An Independent Review of the Accelerated Retrieval Project

The Department of Energy
Idaho Operations Office

April 30, 2004

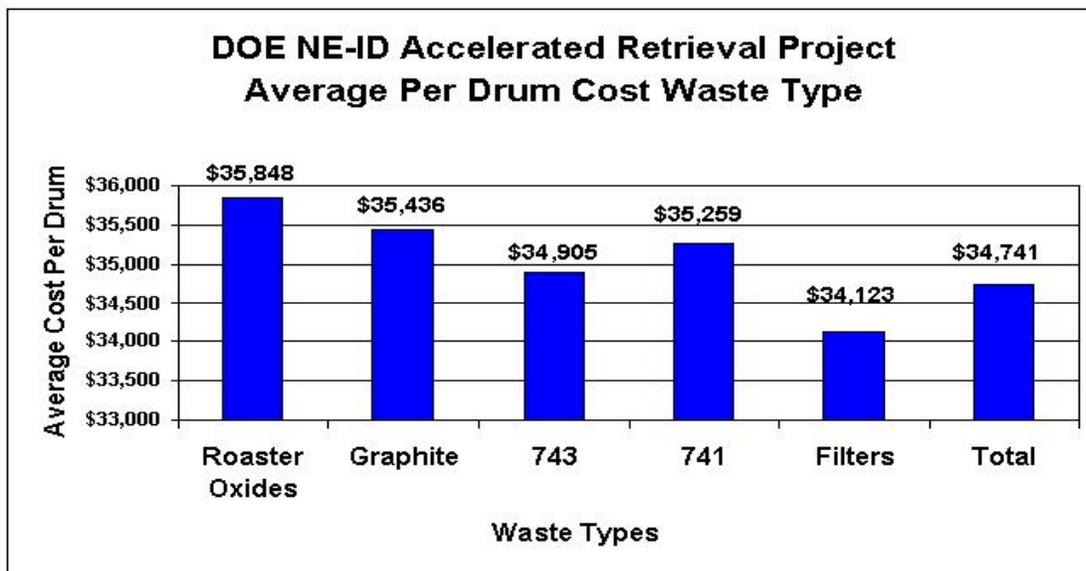
- Discussions are on-going with the regulatory agencies regarding the projects' concepts and methodologies.
- Revised M&O contractor estimate (4-28-04 factual review) for targeted TRU waste. Revised estimate from 6,046 to 12,500 drums. Storage capacity estimate was revised to ~10,000 drums. A statement was also made about changing retrieval operations from 13 months to ~18 months. Due to the timing of the new information, impacts to schedule and costs from the revised estimates were not evaluated for this report.

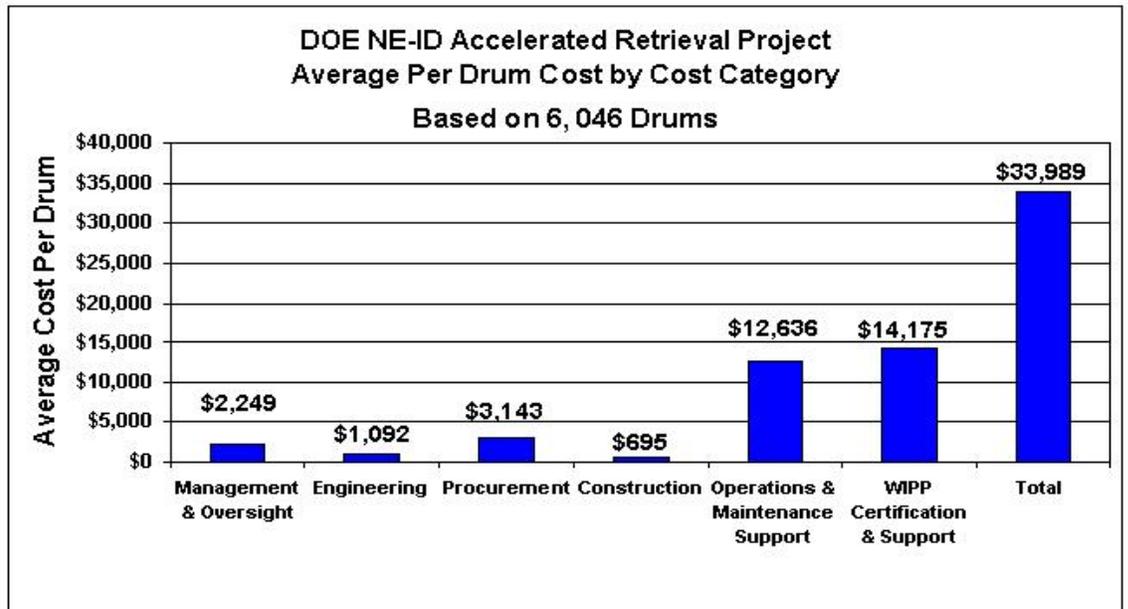
At ~\$85M total characterization and shipping costs and an estimated 6,046 drums, this equates to over \$14K per drum unit cost. (See Figure 12 below.) Similar independently derived figures from the 3,100 m³ Project (averaged over the life of the project) include:

- \$6K per drum shipped to WIPP (Tonkay Method)
- \$9.5K per drum shipped to WIPP (CABE Method)¹³
- New drum estimates (***new information referenced above***) equate cost to ~\$6.8K per drum shipped to WIPP.
